PROPOSED TECHNICAL SPECIFICATION CHANGE

SURRY POWER STATION  
UNIT NOS. 1 AND 2

OFF-SITE ORGANIZATION FOR  
FACILITY MANAGEMENT AND TECHNICAL SUPPORT

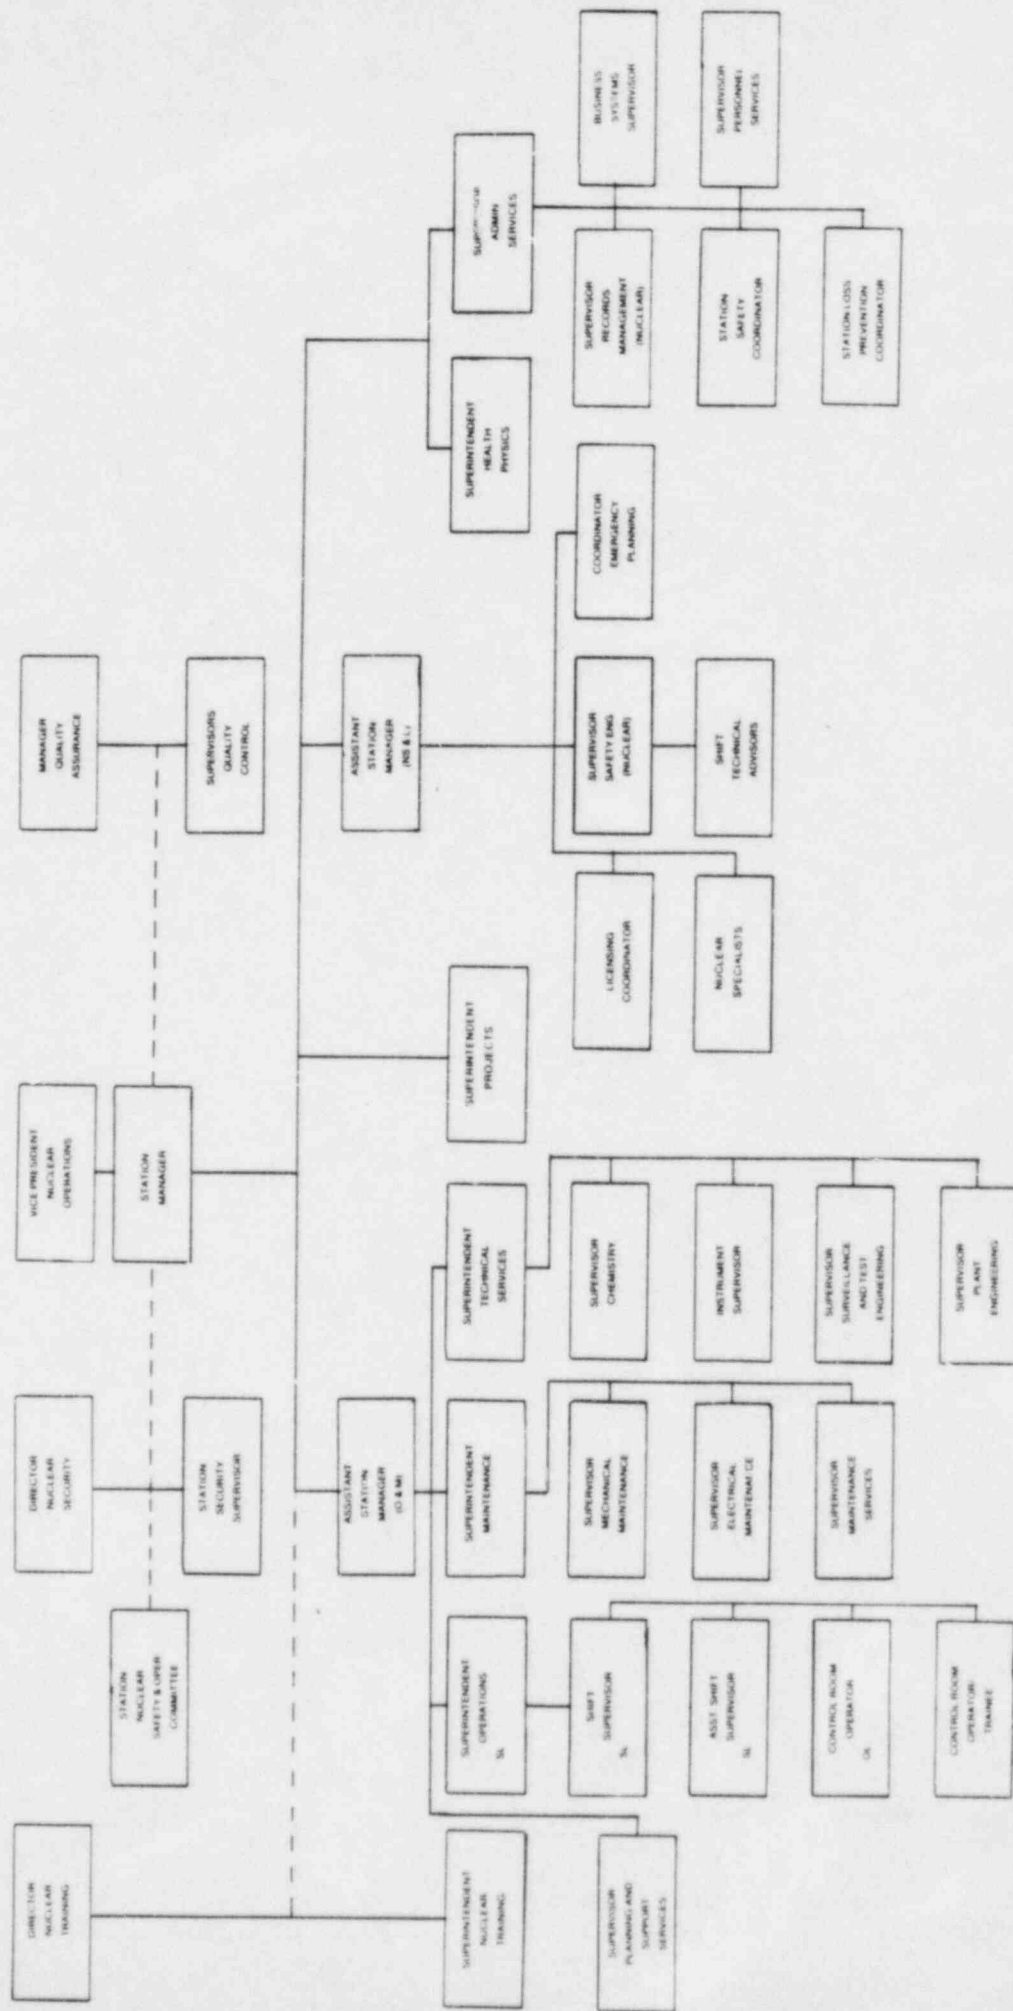
This proposed change will modify Section 6 of the Surry Technical Specifications to reflect a company reorganization in which the Quality Assurance organization will now report to the Senior Vice President - Engineering and Construction, rather than the Senior Vice President - Power Operations. It also corrects the titles of several on-site and off-site supervisors. As the major emphasis of the Company's nuclear program is on operations rather than construction, it is appropriate that the QA organization report to Engineering and Construction to enhance the independence of the QA organization.
